TOWN OF MARBLETOWN PLANNING BOARD MINUTES

Date: February 21, 2018
 Rondout Municipal Center, 1915-1925 Lucas Avenue
 Meeting Room C-4
 Cottekill, New York 12419

APPLESTONE MEAT CO. REVIEW

Re: Applestone Meat Co. Revised Site Plan

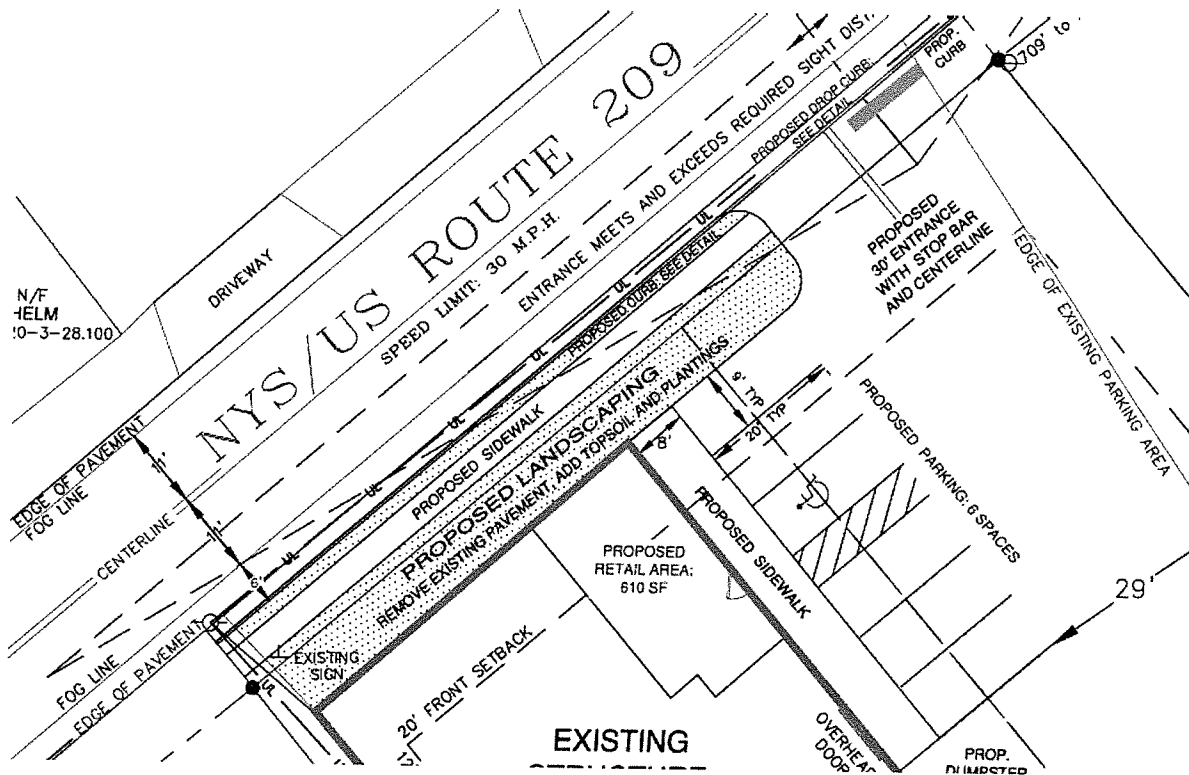
14. Parking. Parking lots abutting public streets shall be separated from the street by a buffer area of at least five feet in width which includes trees or low walls, or hedges or shrubs or a combination thereof. This was not addressed for the existing parking lot at the frontage with Route 209. See the excerpt from the previous site plan – screening the parking lot should be addressed at this time.
